Re: Certificate of Appropriateness for 104 E Gilman Street

Project Name/Address: 104 E Gilman, Kendall House

Application Type: Certificate of Appropriateness for exterior alterations on a landmarks site in a historic district

Requested Action: The Applicant is requesting that the Landmarks Commission approve a Certificate of Appropriateness for an exterior alteration at the Kendall House in the Mansion Hill historic district involving the construction of brick piers in the front porch, installation of light fixtures on two of the piers, and repair and replacement of a decorative baluster located in front of the centrally located dormer on the primary elevation.

Coach lights:

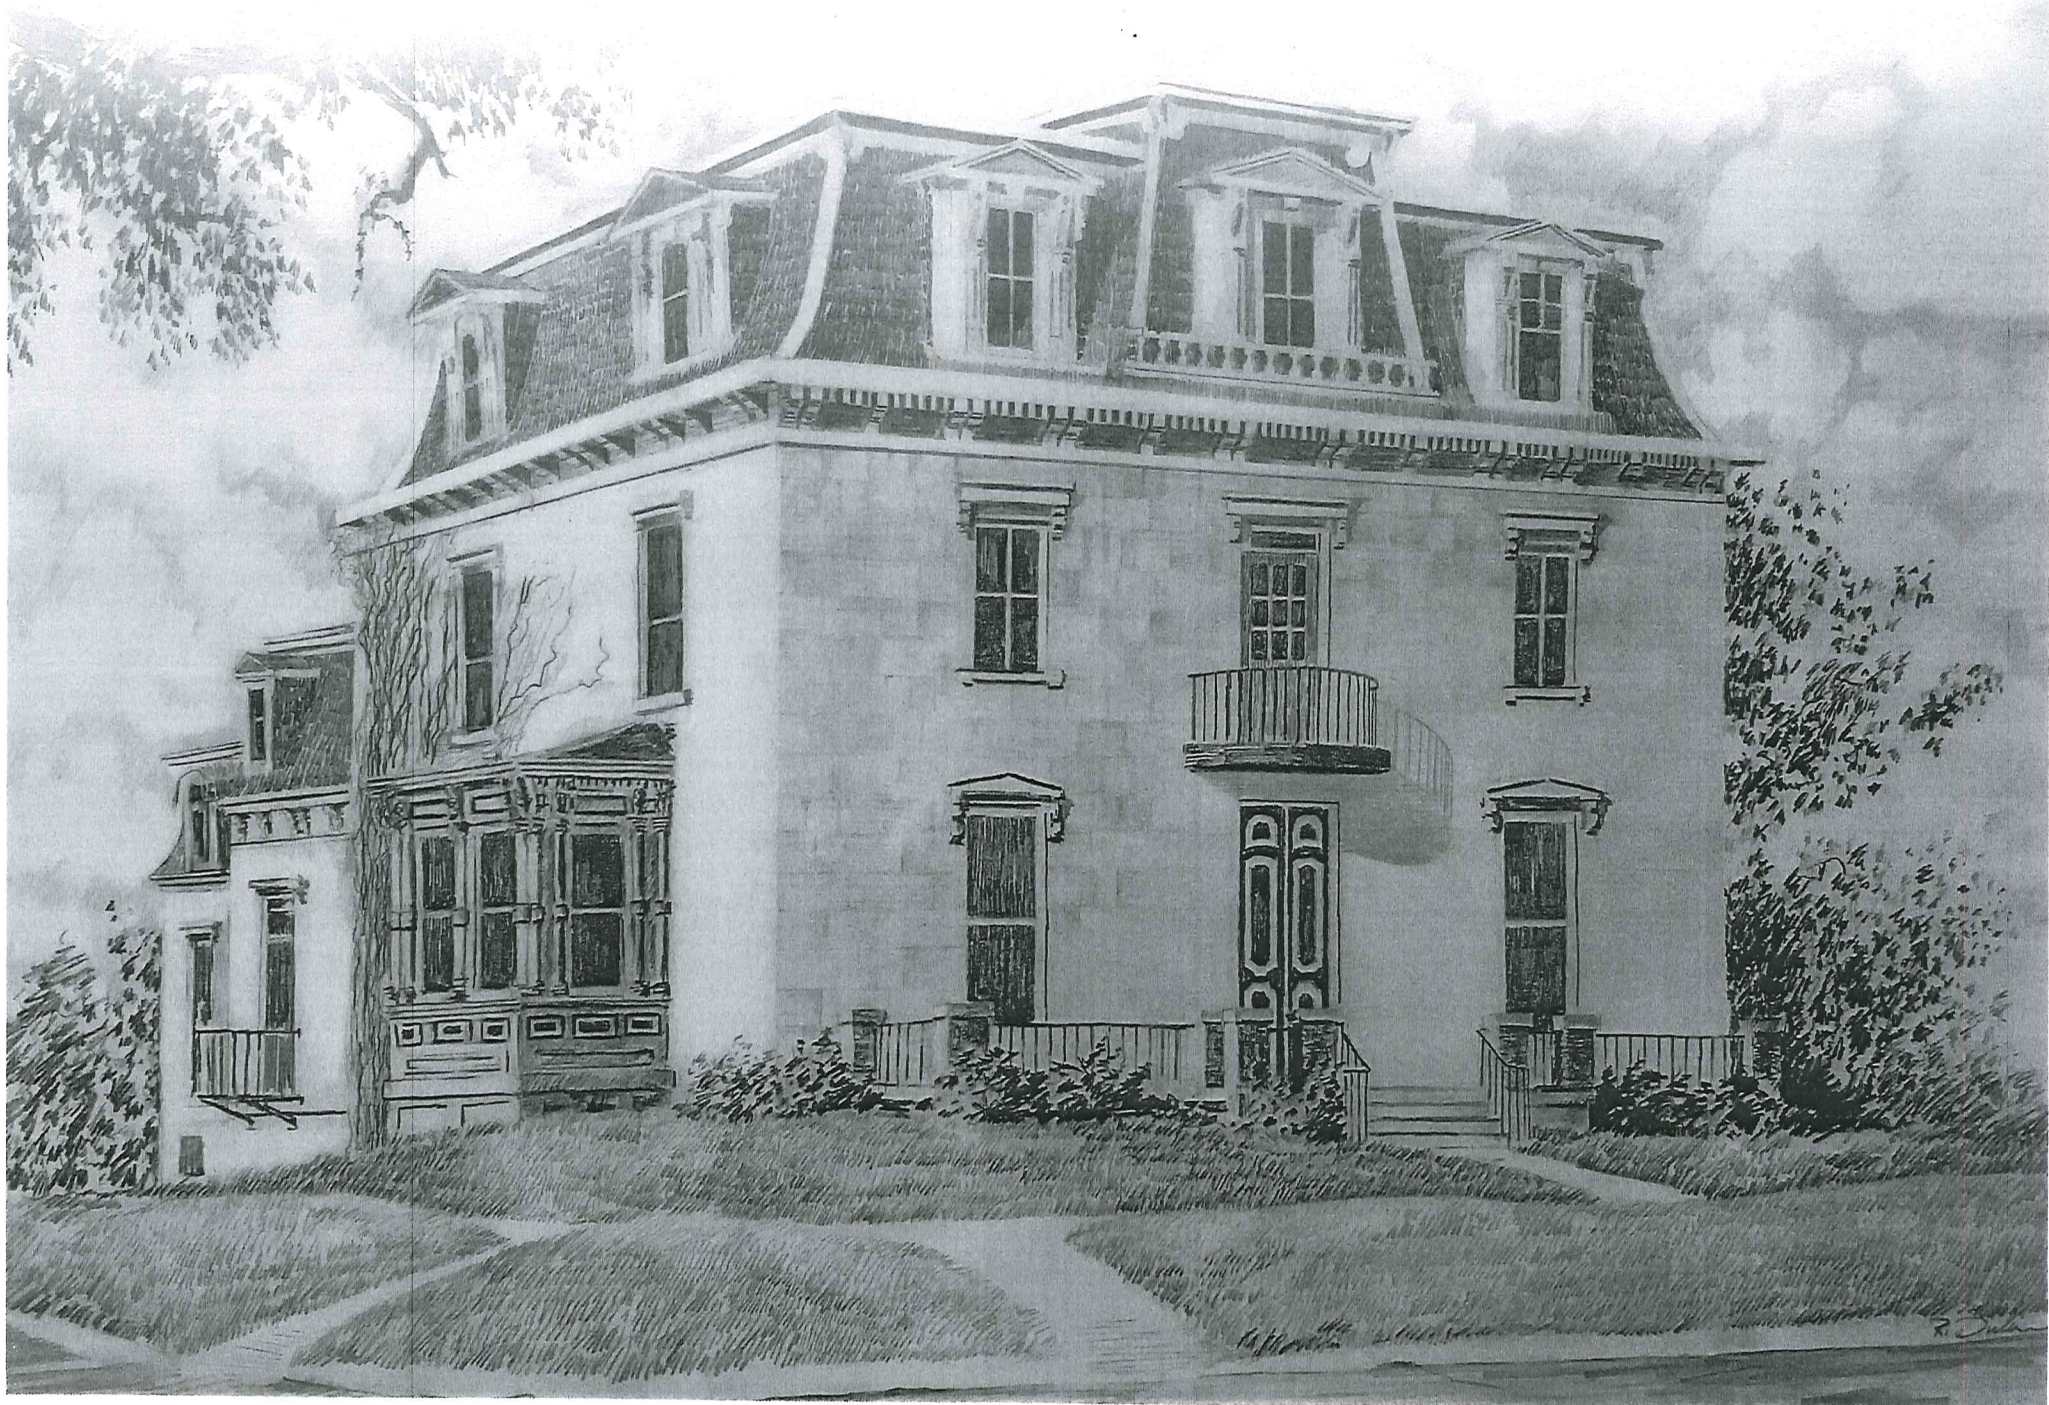
1. The caps of the piers that have been drilled for light fixtures shall be covered or replaced so that wiring cannot be accessed for the installation of light fixtures. It would be more appropriate to add light fixtures directed toward the stairs in a lower portion of the pier than to mount fixtures to the tops of the piers. Any light fixture installation would need the review and approval of the Landmarks Commission. If the caps are replaced, they should have a pyramidal sloped top surface instead of being flat. In addition, the overhang should be reduced so that the cap is more appropriately sized to the pier.

As for the coach lights proposed on the two center columns, we felt added elimination at the steps would create a safer and more inviting feel. Lighting now is provided by 2 can lights under half round porch. For this reason we would like to keep this feature, but realize this is not original to the property (but neither are the lights above entry). We will submit several choices for the light to minimize distraction and still create a safe and inviting entryway.

A1.0 Front Entrance Replacement Plan

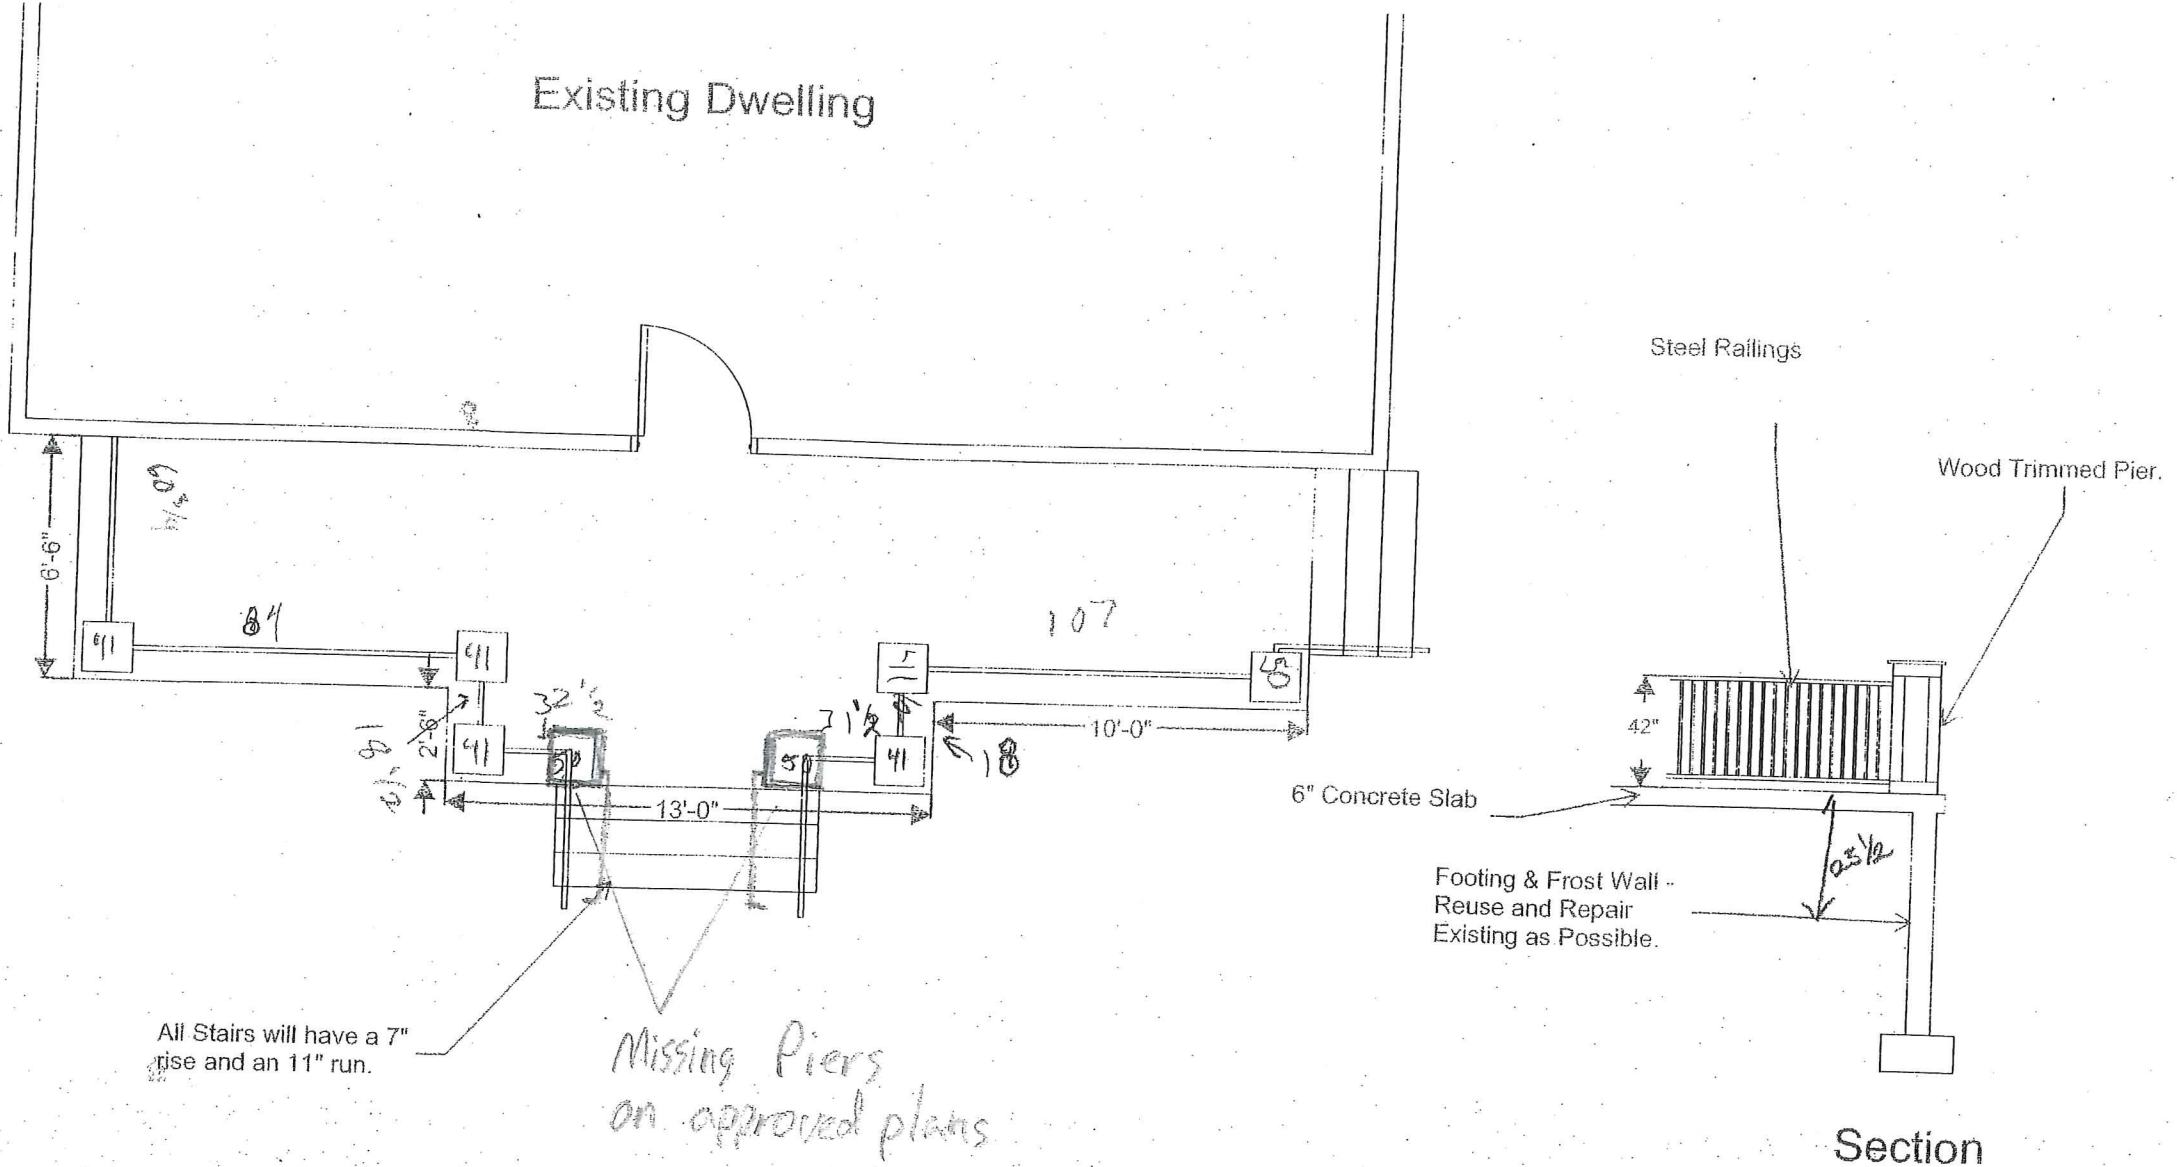
2. The middle piers shall be reduced in height so that they match the height of the other piers.
3. The east corner pier should be reduced in height and width so that it matches the height and width of the other piers. The cap should be made smaller so that the overhang matches the overhang of the other piers.

4. An engaged pier shall be constructed to match the existing engaged pier on the opposite side.
5. If the proposed porch railing does not meet Building Code, the applicant must submit a modified design to staff for approval.

We are asking to keep masonry pier as opposed to wood because brick was the material removed. As to size difference the three larger piers are positioned to accept hand railings to the staircases and are larger to create anchor points. The height of columns will depend on approved railing heights and design. The caps were sized according to close approximation of what was there before.

Railing Detail

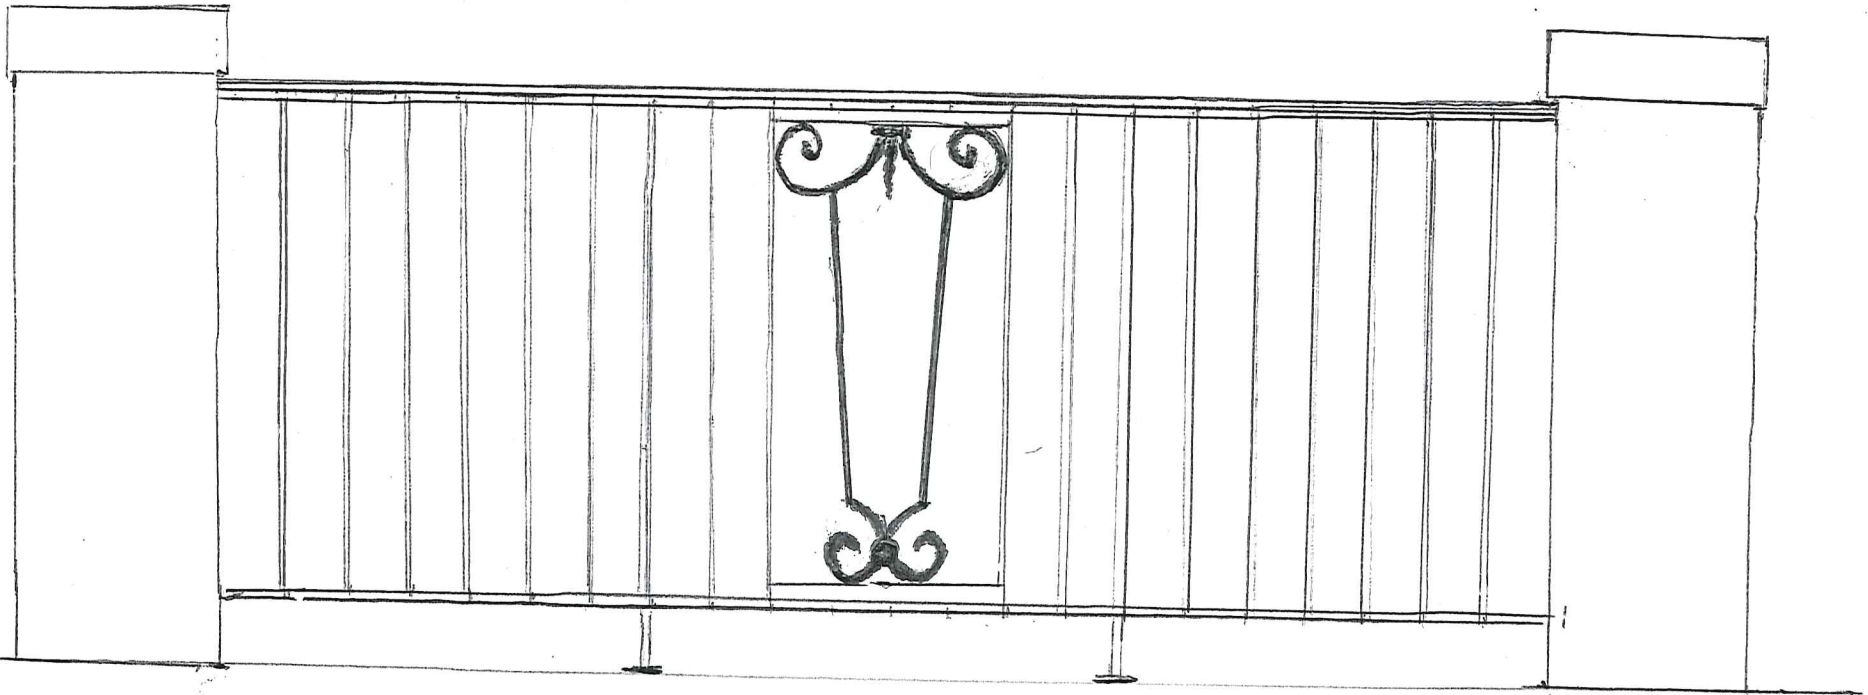
a. There was historic documentation for the porch that had been in place both historically, but the applicant altered the design rather than reproduce the previous porch. The proposal is to introduce the salvaged decorative panel on the railings if it meets building code.

We are submitting plans for a new wrought iron railing. The original railings were in poor condition, but the artistic panel can be salvaged and incorporated into the new design (see drawing). Though the porch height is currently over 24 inches we propose to alter the landscaping to allow for the use of more historically appropriate 36 inch railing height.

center detail salvaged from original railings

Railing 32 $\frac{1}{2}$ " tall
4" off ground
